REQUEST FOR TENDERS
MODIFICATIONS AT THE SERENGETTI BUSH CAMP (SBC)
RFQ 27 (2022-04)
ADDENDUM #1

**SERENGETI BUSH CAMP
SITE UPGRADES**

PROPOSED
CAMP LAYOUT

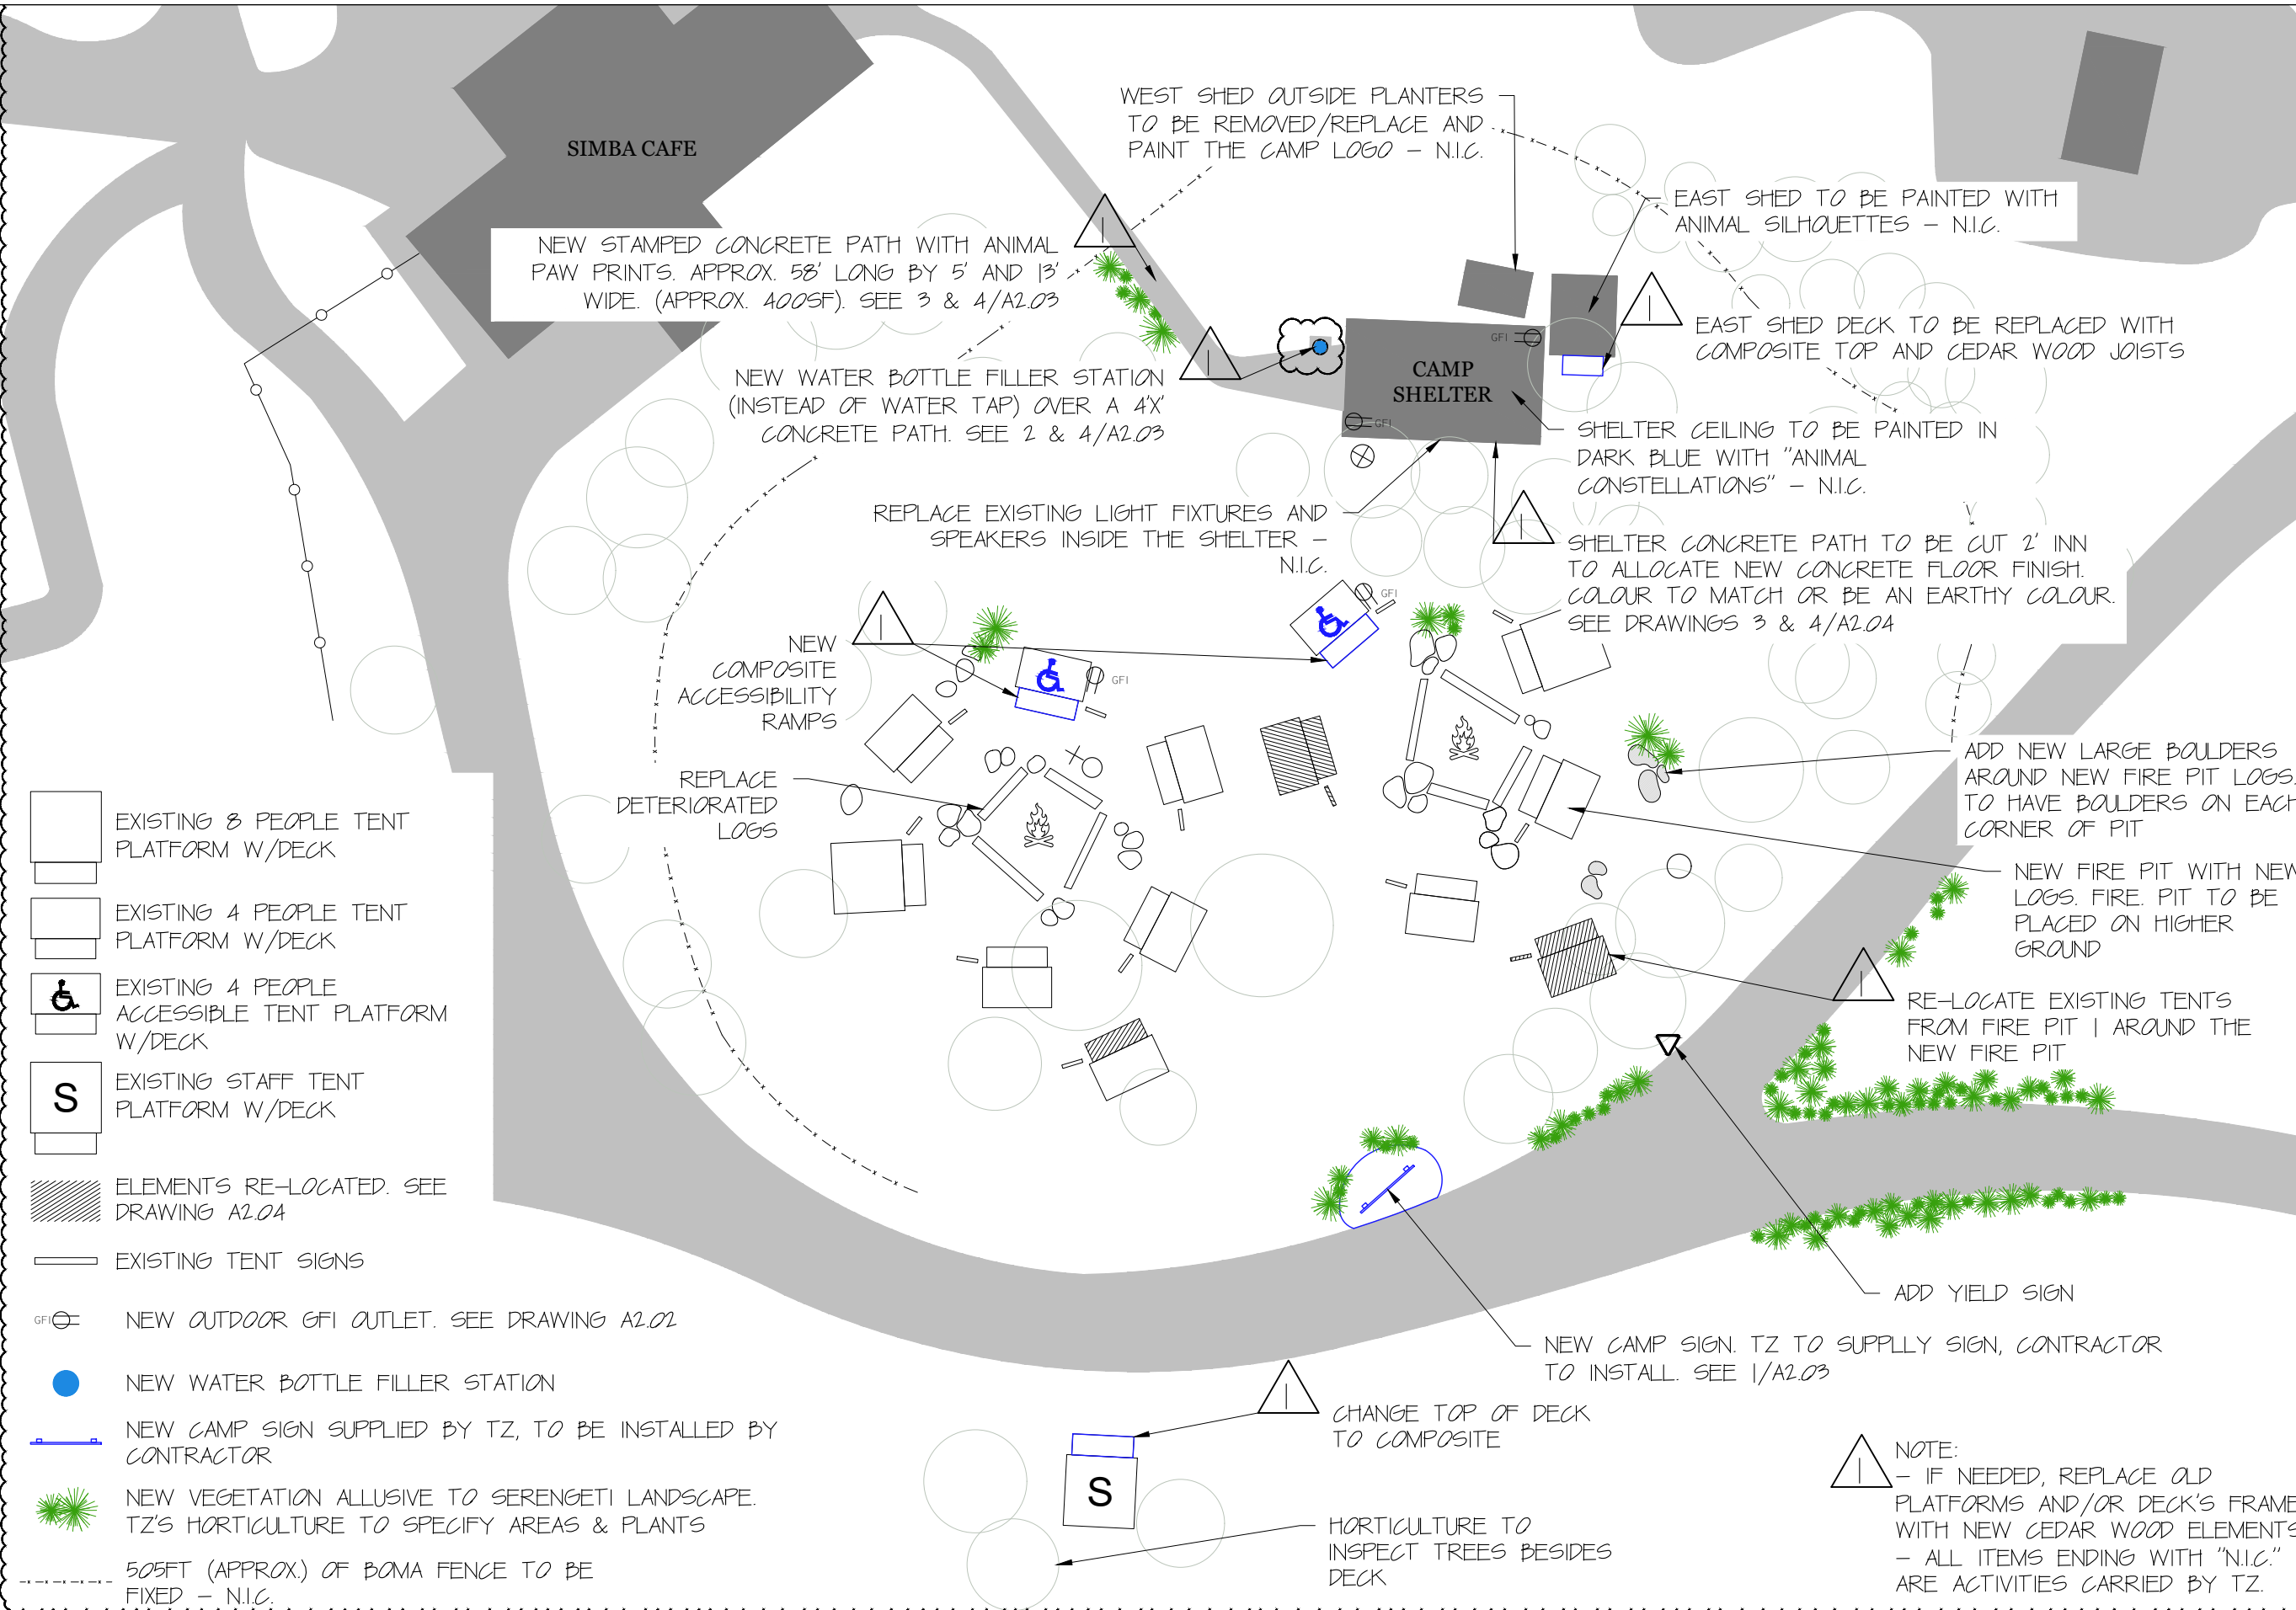
Install a new fire pit (to be located on higher ground as marked on the plans). TZ to supply rocks as needed. New fire pit to match existing? Confirm size of new fire pit including depth.

Relocate the existing tent decks:

- a. West Fire pit. Must have 7 decks.
- b. East fire pit (new one). Must have 6 tent decks. These tents must be placed around the new fire pit. Confirm location
- c. Wheelchair accessible ramps. They need to be relocated (as shown on the drawing) beside the decks closest to the concrete path and camp shelter. Each fire pit must have one (1) tent with ramp.

The firepit is approx.. 8' in diameter. The perimeter is surrounded by the small rocks/boulders. There is no depth requirement for the fire pit. The rocks can be placed on grade (some digging may be required to stabilize the rocks)

Question unclear. Please reference drawings.

**SERVICES - EXISTING
& NEW CONNECTIONS**

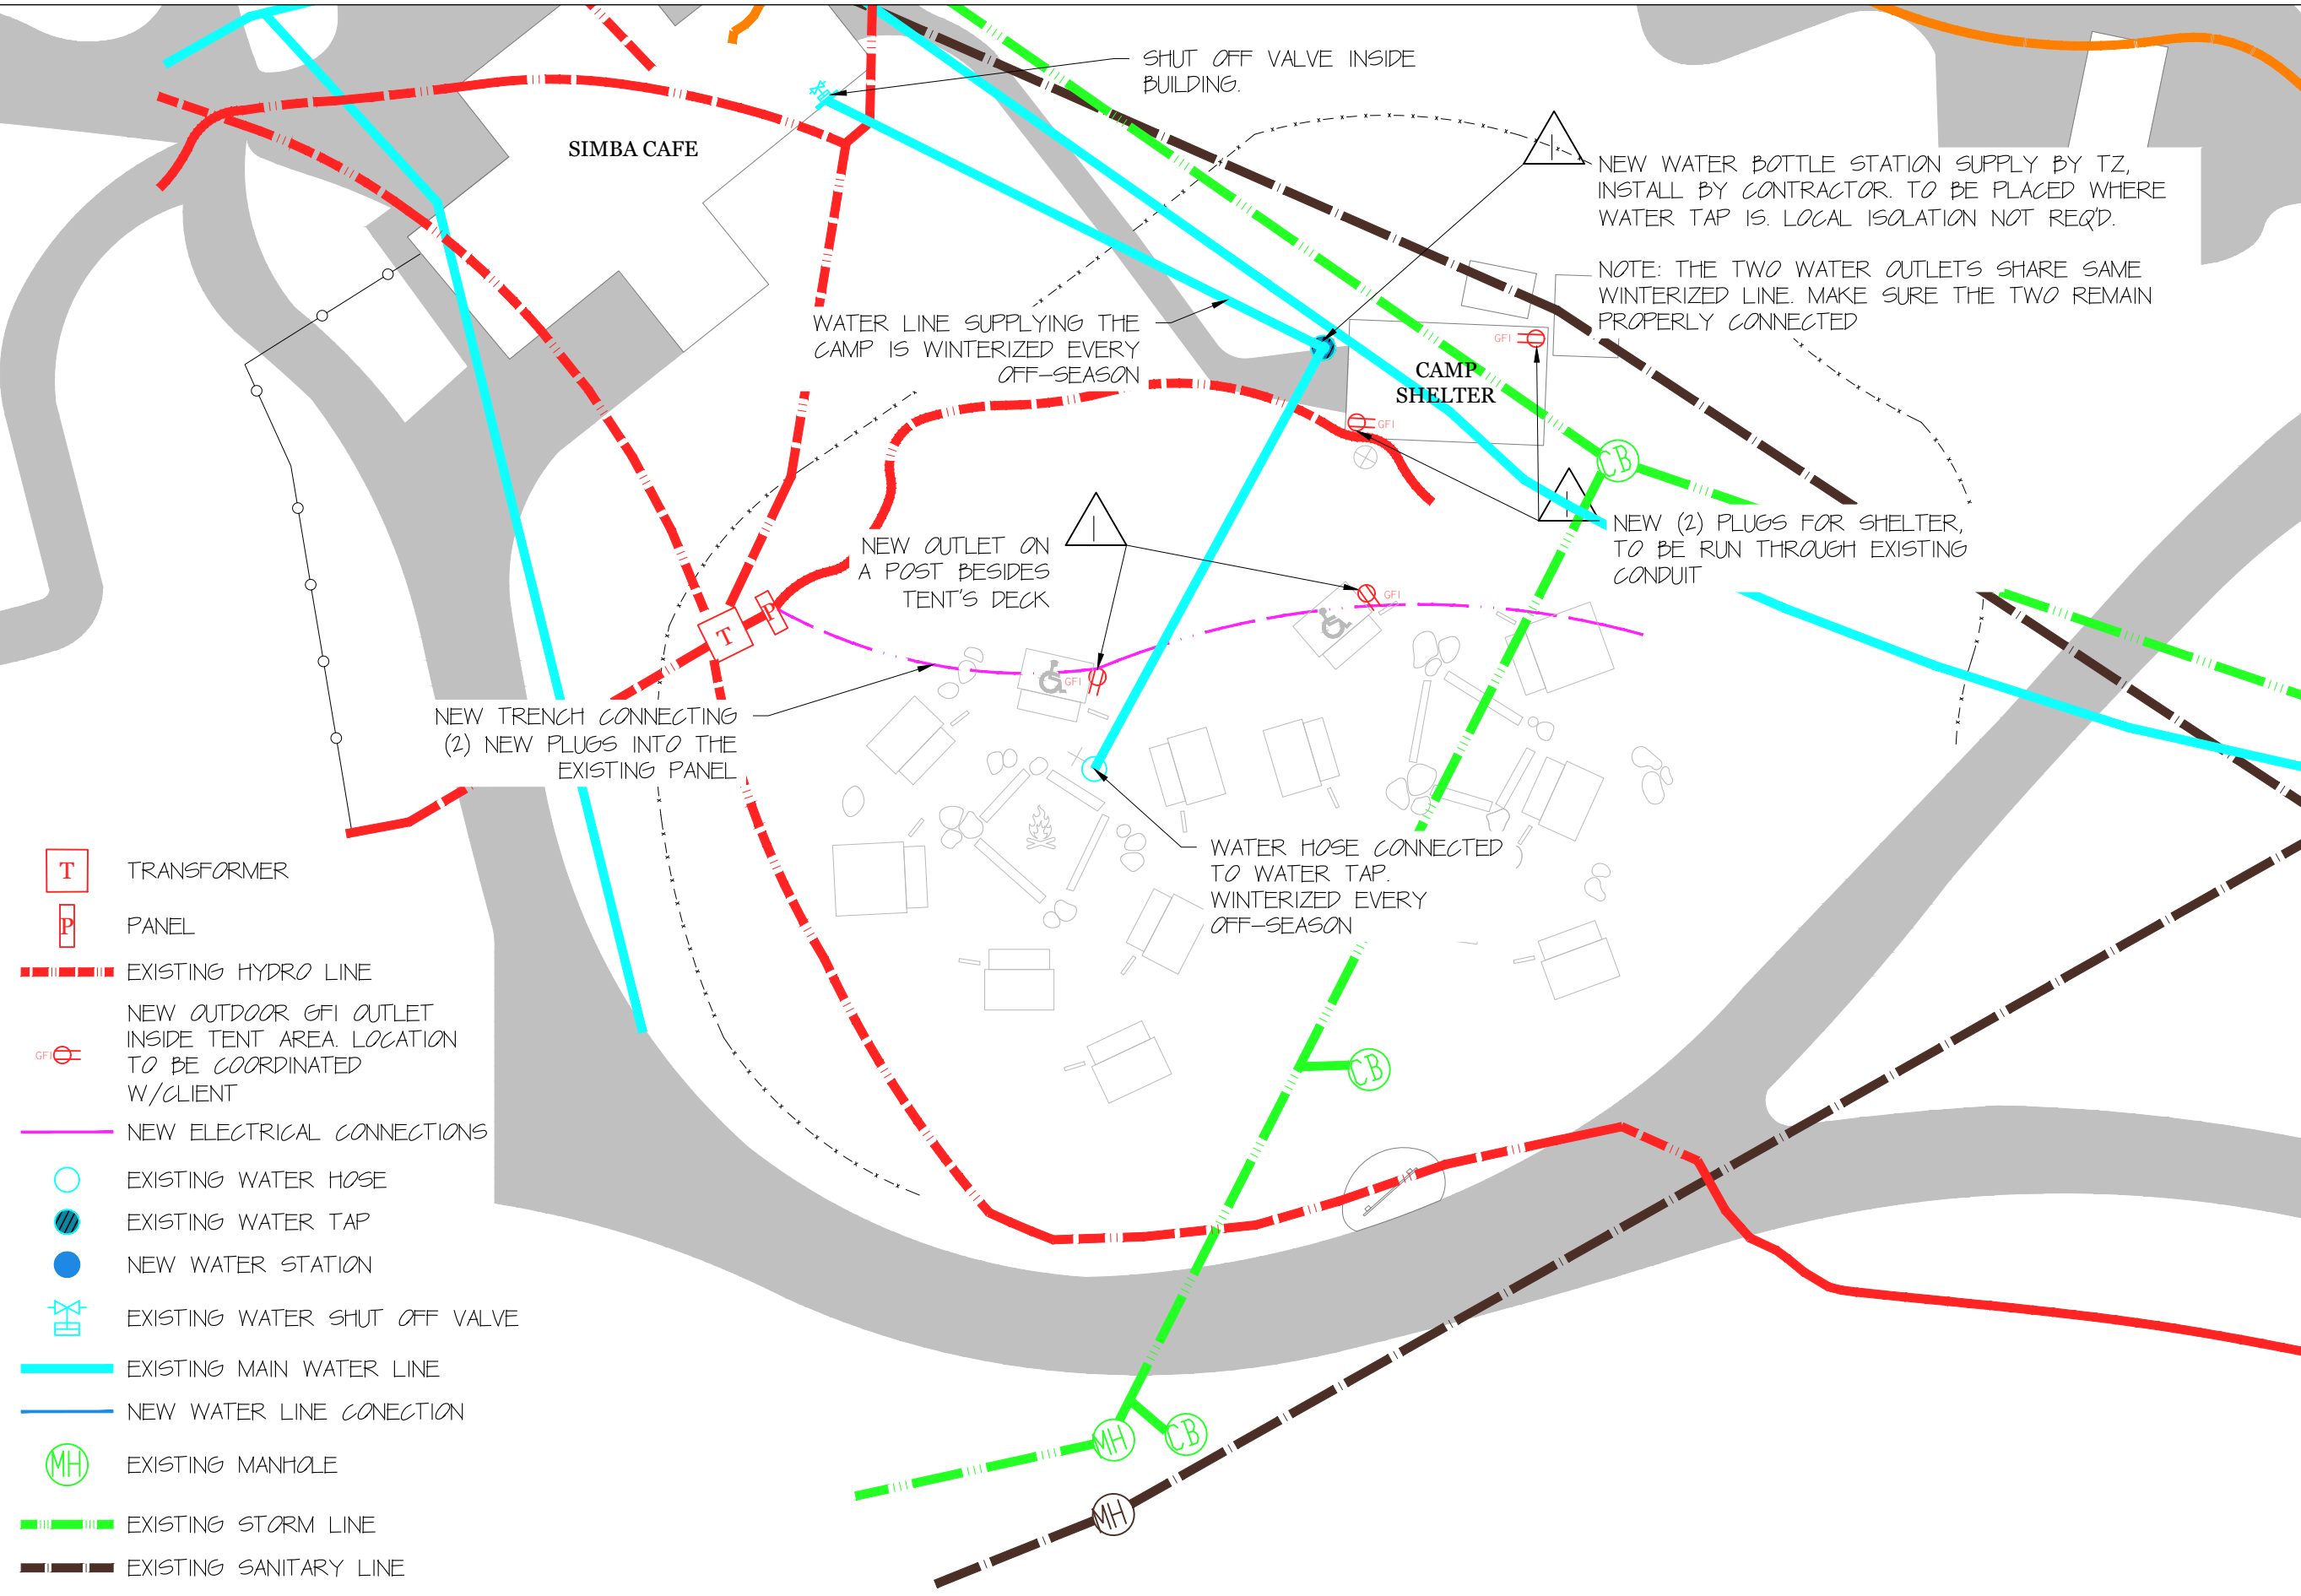
What are we mounting the new duplex receptacles in the tent to? Deck mount receptacle or on a post?

Install two (2) new outdoor duplex receptacles on one tent of each fire pit. The location to be determined on site but must be in the perimeter of the accessible tent. Confirm where closed electrical panel is located.

Install a new water bottle filler station and connect it to the main water line. Water bottle filling station supplied by the Toronto Zoo. See drawing A2.02.

RESPONSE:

New receptacles to be mounted to posts. Please reference drawings in this addendum.

Please reference drawings.

Question unclear. Please reference drawings.
